Fort Calhoun Station, Unit No. 1
Renewed Facility Operating License No. DPR-40
NRC Docket No. 50-285

SUBJECT: Safe Shutdown Analysis (SSA) RAI Response - NFPA-805 Transition (ME7244)

SSA RAI 17.01

REC-117 – Proposed Design Option

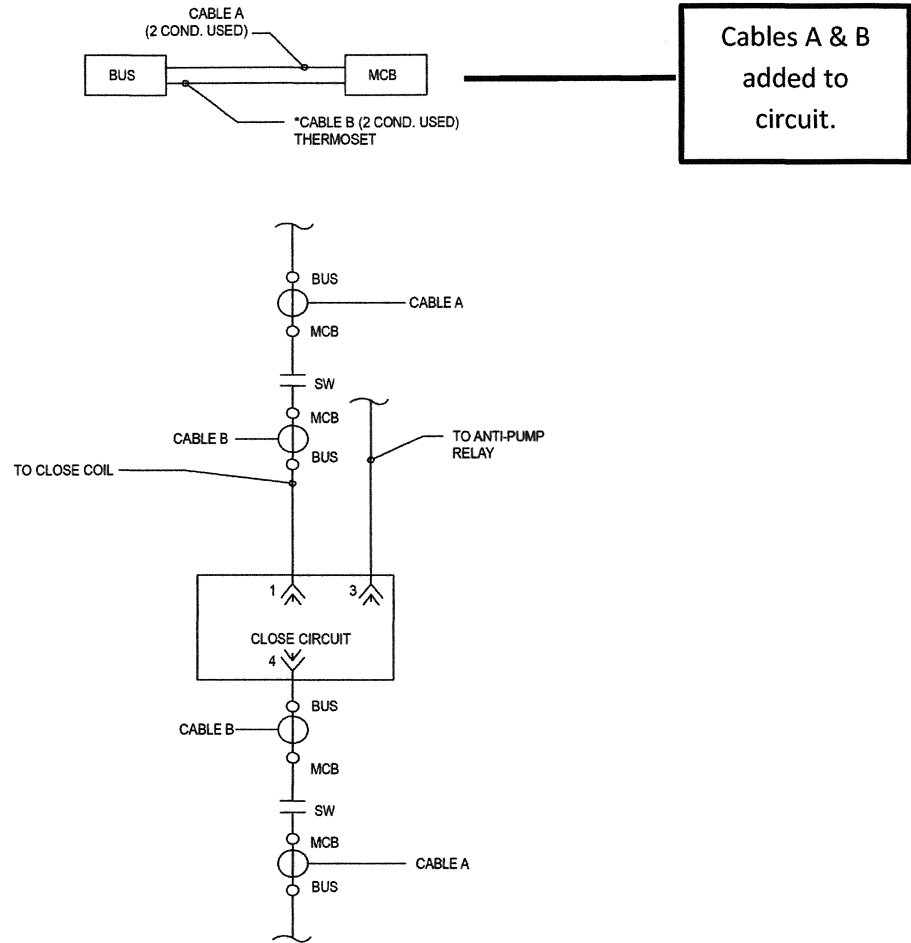
License Amendment Request, Attachment S, Table S-2, "Plant Modifications Committed," Item REC-117, states:

"Modification to change the normal operating alignment for 480 V load center tie breakers BT-1B4A, BT-1B3B, and BT-1B4C from normally open and racked-in, to normally racked-out (or otherwise disabled from spuriously closing due to fire damage to DC breaker control circuits in the opposite Train 4kV switchgear room, main control room, or cable spreading room). This modification addresses the issue associated with electrical failure resulting from spurious connection of out-of-synch power sources (offsite power to diesel generator, diesel generator to diesel generator)."

It is further stated that: "The proposed modification will maintain breaker manual trip capability from main control room, protective trip, automatic load shed trip and accident signal trip for fire areas 36A, 36B, 41 and 42."

According to NRC Special Inspection Report dated March 12, 2012 (ADAMS Accession No. ML12072A128), there are interconnecting control wires (operated at 125 V DC) between 480V tie breakers in Electrical Switchgear Fire Areas 36A (East Switchgear) and 36B (West Switchgear) (typical - between breakers BT-1B3A and BT-1B4A). These wires are used in the control circuitry of the breakers. A fire in these breakers in either Switchgear Fire Area 36A or 36B can cause damage to the control wires (such as shorts to ground) in the opposite area breakers.

During a recent inspection conducted from July 22, 2013 to July 24, 2013, Office of Nuclear Reactor Regulation (NRR) reviewers questioned the plant technical staff about the potential negative impact of performing the design change (modification) to rack out the normally open cross-tie breakers on the 480VAC switchgear. Discussions with plant staff indicate that a contingency plan exists to modify the control circuit to preclude spurious closure should the modification to rack out the breaker be deemed impractical.

By letter dated September 18, 2011, the licensee stated, "... (or otherwise disabled from spuriously closing due to fire damage to the DC breaker control circuits in the opposite train 4kV switchgear room...)." The committed modification is not specified in sufficient detail for the NRC staff to determine its acceptability due to the open-ended parenthetical. Please provide a written description of the specific modification that will be implemented as part of the NFPA 805 transition as well as conceptual circuit design sketches indicating the existing portions of the circuit as well as those parts being added/modified.

A circuit design sketch and written description of the modification that will be implemented as part of the NFPA 805 transition is attached.

Circuit modification to prevent spurious closure of normally open bus tie breaker resulting from hot shorts.

The above figure shows the proposed circuit modification to prevent spurious closure of the normally open bus tie breakers BT-1B4A, BT-1B3B, and BT-1B4C. Contacts from the existing breaker control switch (SW) will be added to the breaker close circuit to provide isolation to the close coil thereby preventing spurious breaker closure from a fire induced hot short.

This modification will allow the Main Control Room operator to electrically open or trip the associated breaker from the Main Control Room when the associated breaker control switch is taken out of the “pull-to-lock” position.

SW = new breaker control switch in MCB which incorporates a “pull to lock” position (contacts are break before make). Same switch taken to close will close tie breaker (close contacts not shown). Same switch taken to trip position will trip tie breaker (trip contacts not shown).

Cable B is required to be thermoset, with no other conductors utilized other than the two conductors identified above.
